**Consolidated COMMENTS for the Draft UAT MOPS
RTCA Paper No. 132-02/SC186-196**

Proposed Addendum to Appendix M

**Proposed Change to Appendix K
File “surface.doc”**

Proposed Change to Appendix K

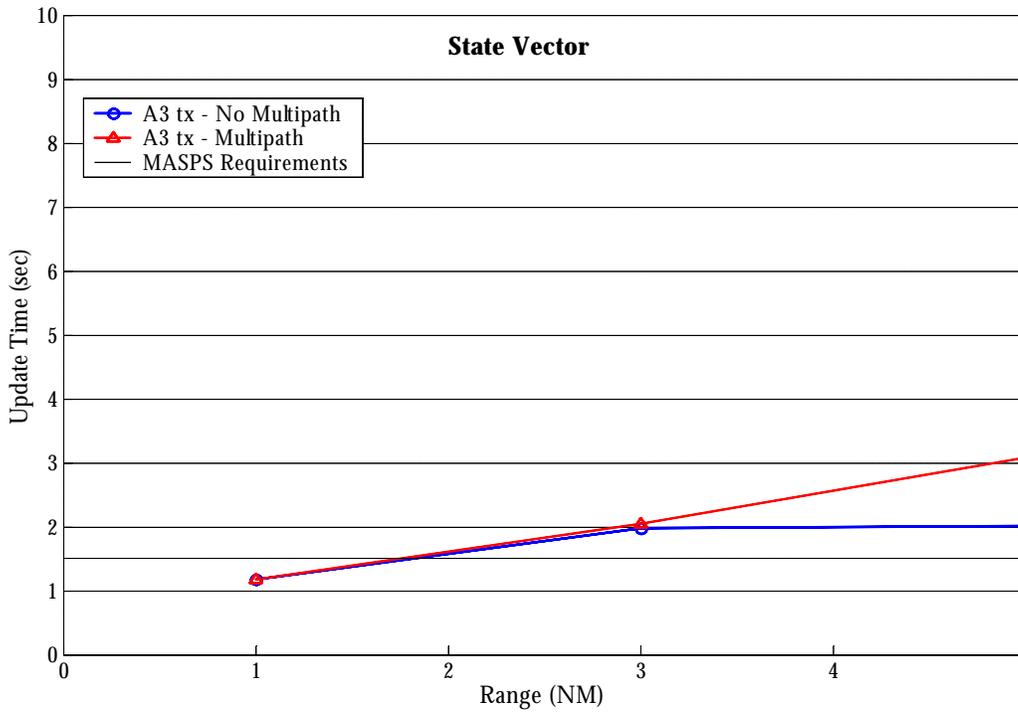
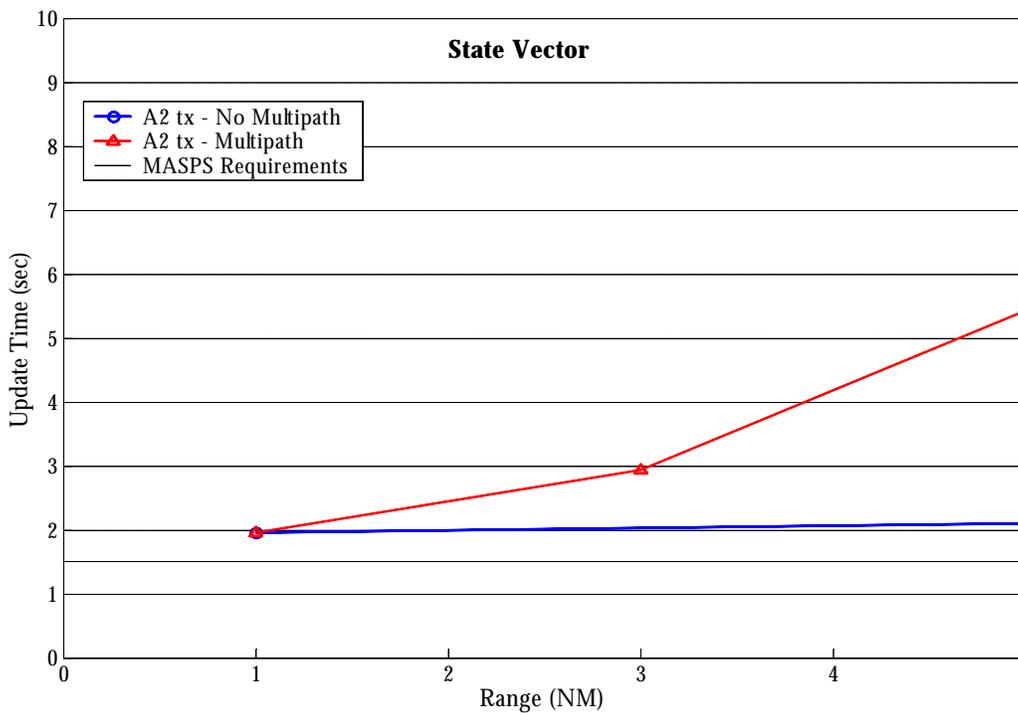
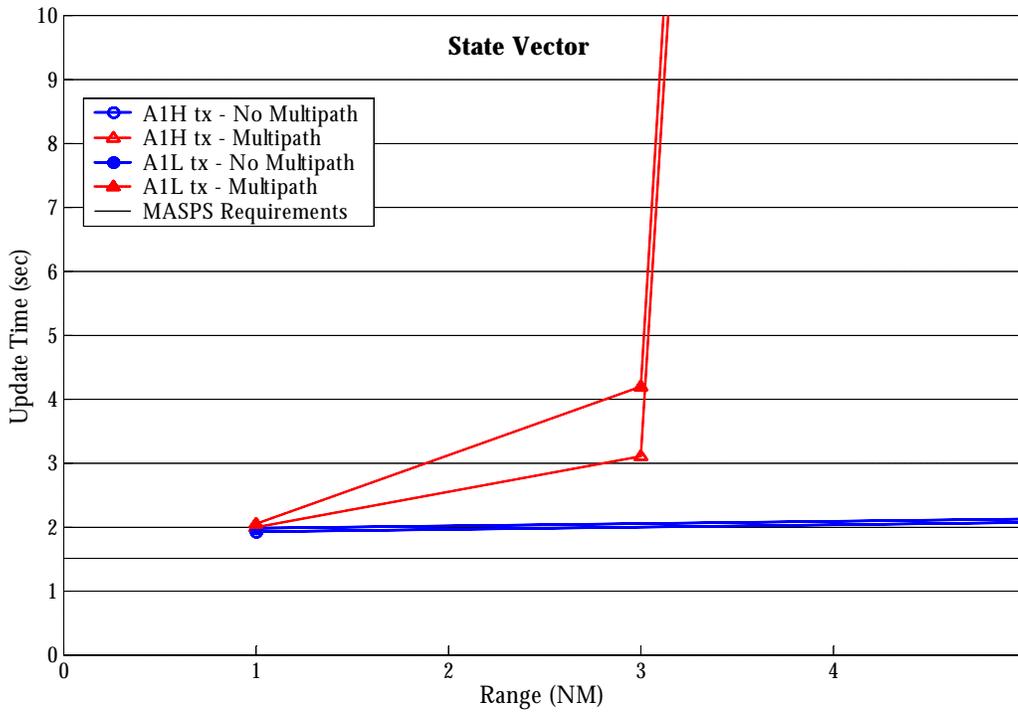
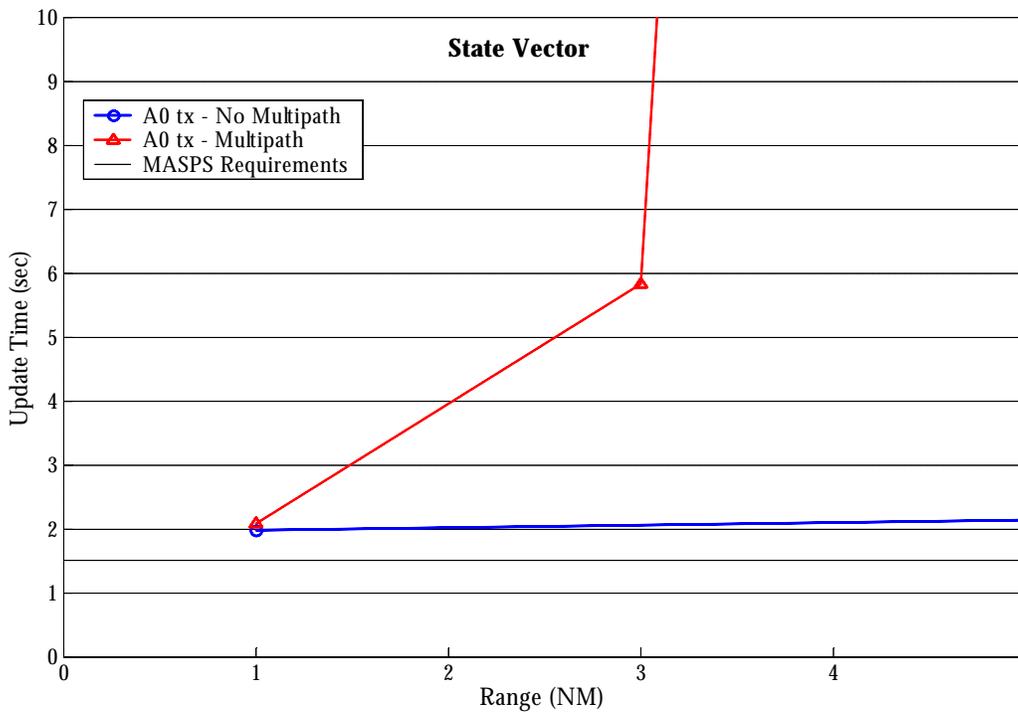
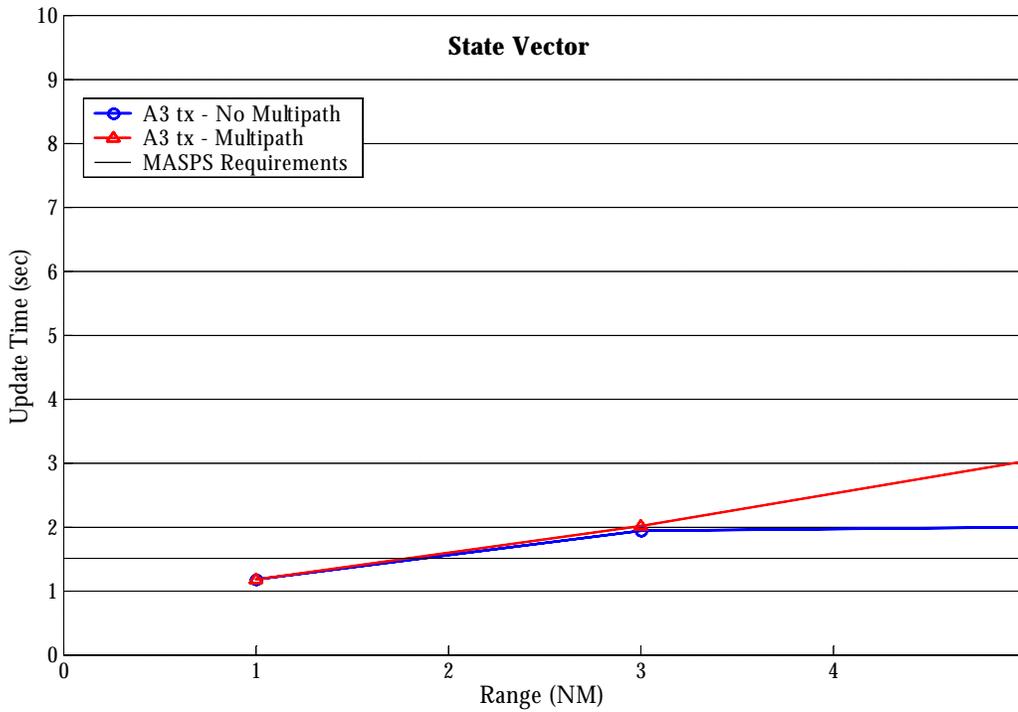
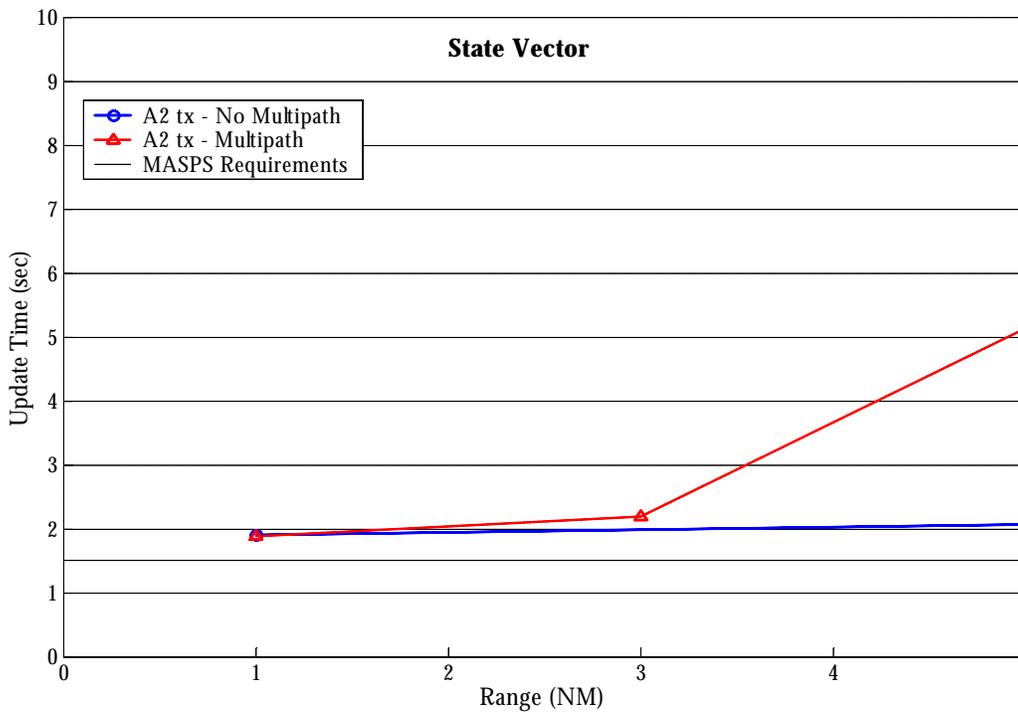
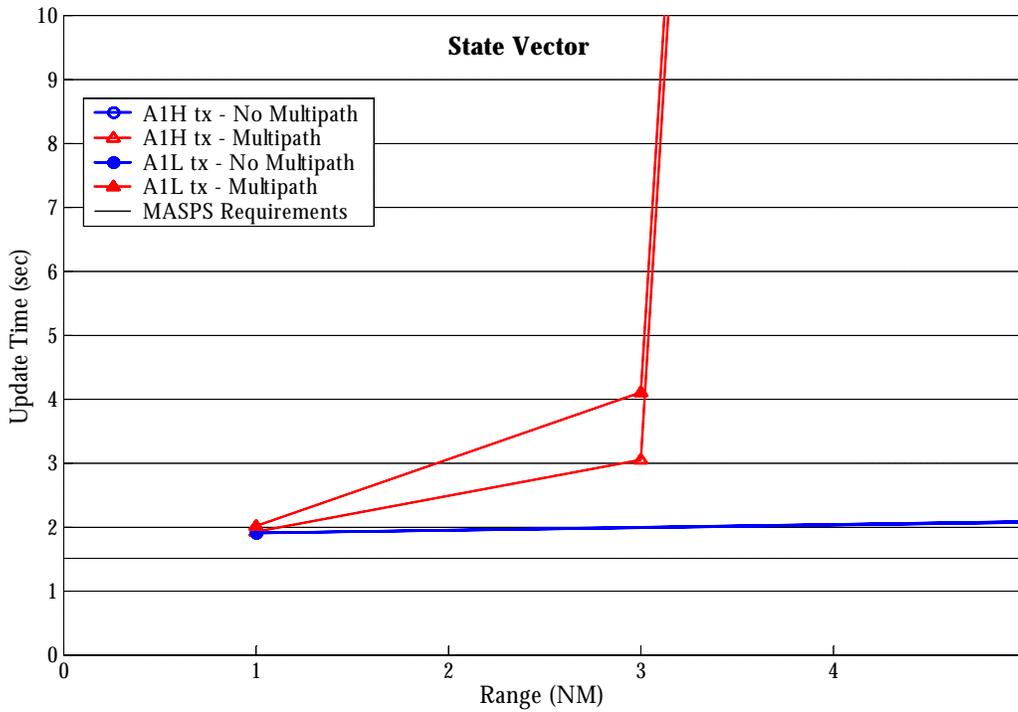
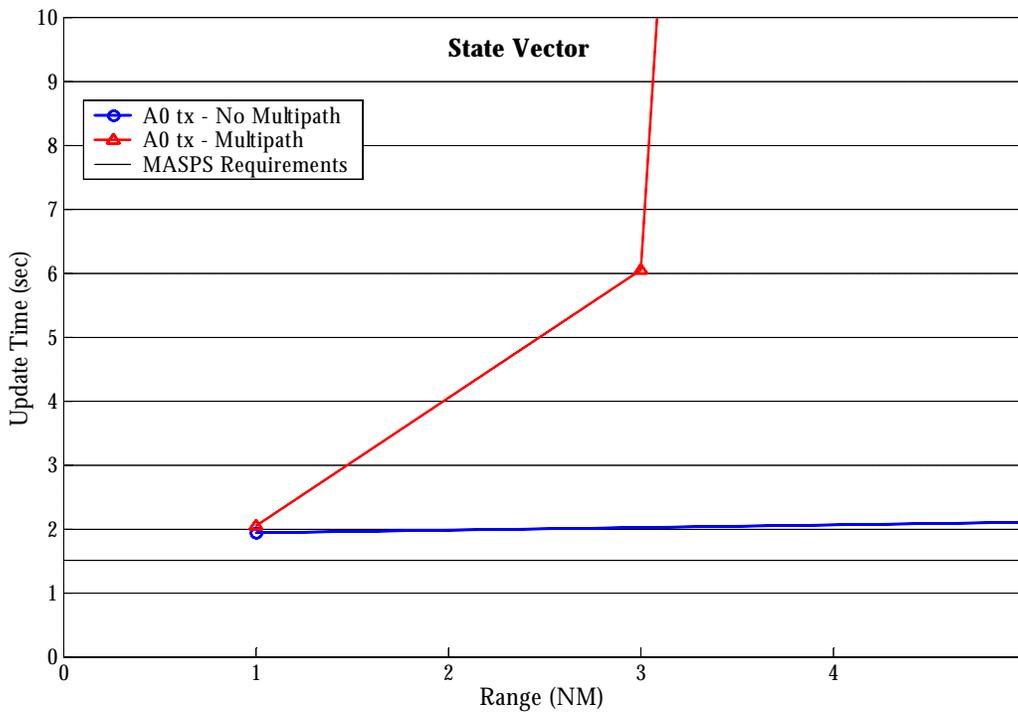
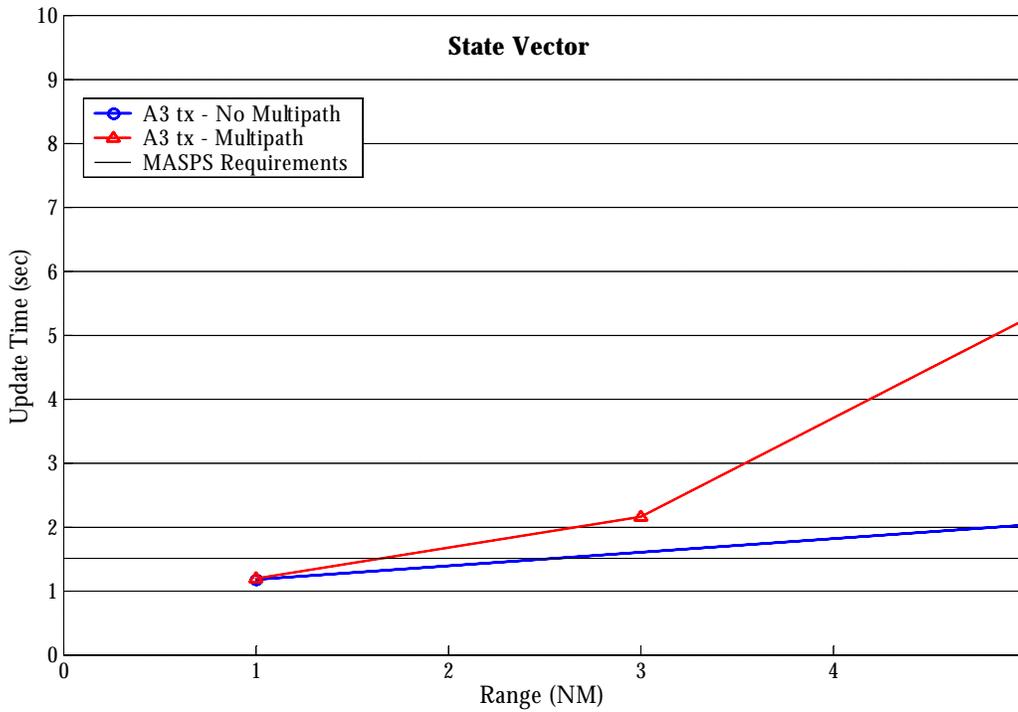
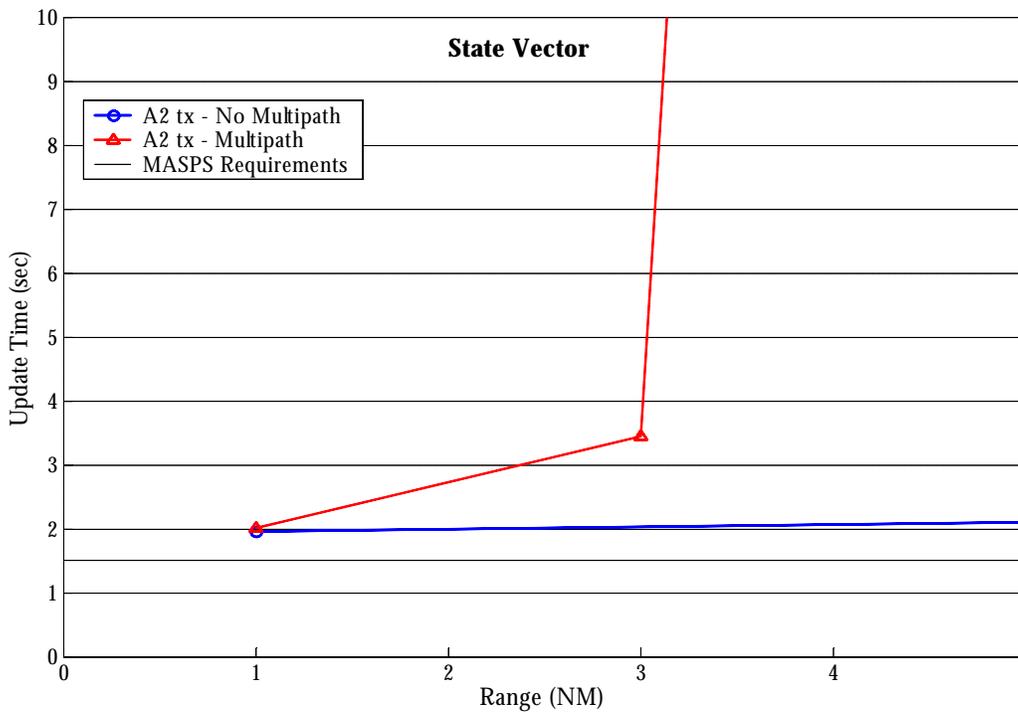
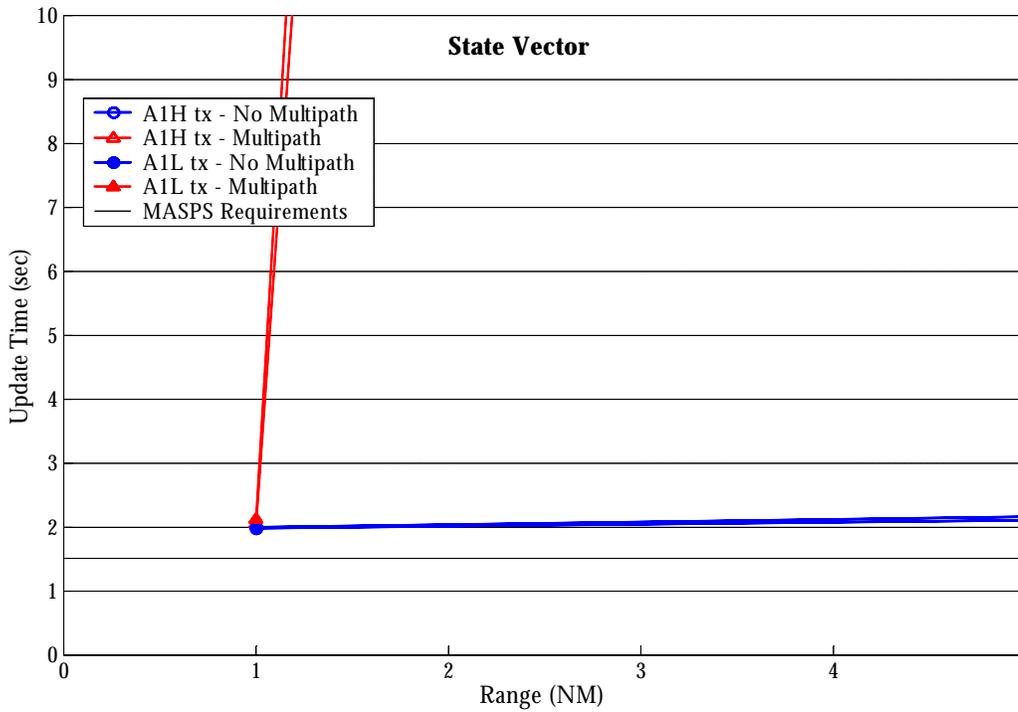
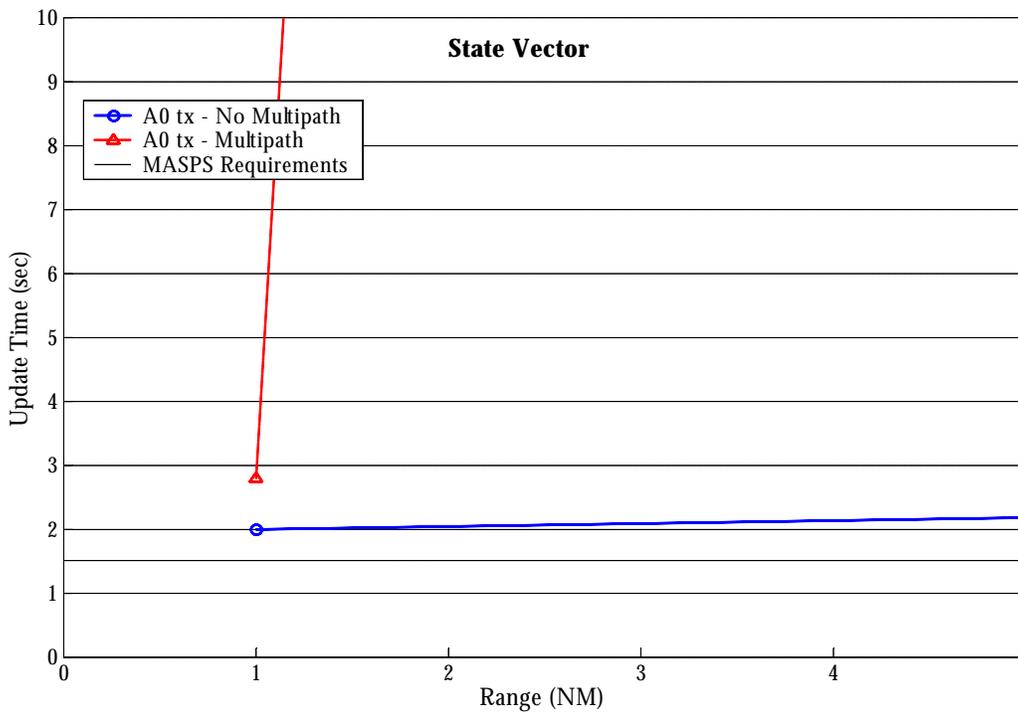
#	Author	Section	Page	Comment	Suggested Resolution
5	JHU-APL	K.4.5	K-76	Section K.4.5 results and conclusions do not correspond to requirements on surface	<p>Replace text after first three paragraphs of K.4.5 with attached document “surface.doc”, which updates Figures 110-125 and conclusions</p> <p>WG-5 Response: Attached document inserted with summary having been modified from the original. Done</p>
6	JHU-APL	K.4.6 (addition to current K.4)	?	In accordance with Table G-6, Overview of Scenario Assessments, no results for an A0 receiver on the surface receiving aircraft on approach at 2000’ altitude are shown	<p>a) Insert a new section K.4.6 with attached document “A0 on Ground.doc”</p> <p>b) Change name of current Figure K-126 to Figure K-128 to reflect new inserted section</p> <p>c) Add the following sentence at the end of the 4th paragraph of K.1.1: “Section K.4.6 presents the results for a A0 receiver on the surface receiving aircraft on approach.”</p> <p>d) Delete the 2nd paragraph under paragraph K.4.5</p> <p>WG-5 Response: Attached document inserted having been modified from the original. Done</p>

Replace text after first three paragraphs of K.4.5 with this document, which updates Figures 110-125 and conclusions

The results for the aircraft-to-aircraft surface-to-surface performance from Figures K-110 through K-125 may be summarized as follows:

- For the bounding cases with no multipath and with worst-case elevation plane multipath, the 95th percentile surface update requirement for the ADS-B MASPS (1.5 seconds out to 5 NM) are met for A3 transmitters up to 1-2 NM away.

- The 95th percentile surface update requirement for the ADS-B MASPS (1.5 seconds out to 5 NM) are not met for all other cases on the surface.
- The 95th percentile update time on the surface for all aircraft classes to 5 NM for the bounding case of no multipath is approximately 2 seconds. A3 transmitters can be seen by A2 and A3 receivers out to 5 NM with, approximately, a 3 second 95th percentile update time. A2 transmitters can be seen by A2 and A3 receivers out to 5 NM with, approximately, a 5 second 95th percentile update time.

- The 95th percentile update time on the surface for all aircraft classes for the bounding case of worst-case multipath is approximately 3 seconds at a range of 1 NM. The limiting factor at ranges greater than 1 NM is the transmit power and antenna placement for A0 and A1L class equipment, combined with the effect of 175 interferers at close range.
